**Advice
Drainage Plan Farm 70
Salamá, Puntarenas, Costa Rica**

Ir. Henk Ritzema

Alterra, Wageningen, 2007

This report presents a “second” opinion of the drainage plan for the teak plantation Farm 70, Salamá, Puntarenans in Costa Rica. The report discusses options to reduce the risk of high watertables in this teak plantation (71.56 ha).

Table 5. Simulation of the drop of the watertable after the extreme rainfall event on September, 27, 2007

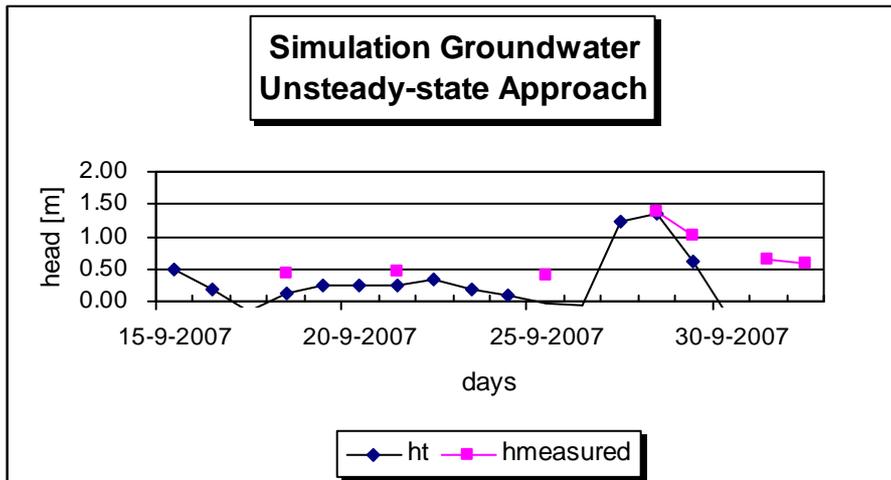
The extreme rainfall event (189 mm) on 27 September 2007 (Report RPS 11-2007) has been used to check the drain spacing using an unsteady-state approach. A

spreadsheet model based on the Zeeuw-Hellinga approach (Ritzema *et al.*, 1998) was used. The results are presented in Table 5.

The simulations indicate that with the selected drain spacing the watertable indeed drops back to 0.90 m after 36 hours. Thus it can be concluded that the selected drain spacing are appropriate.
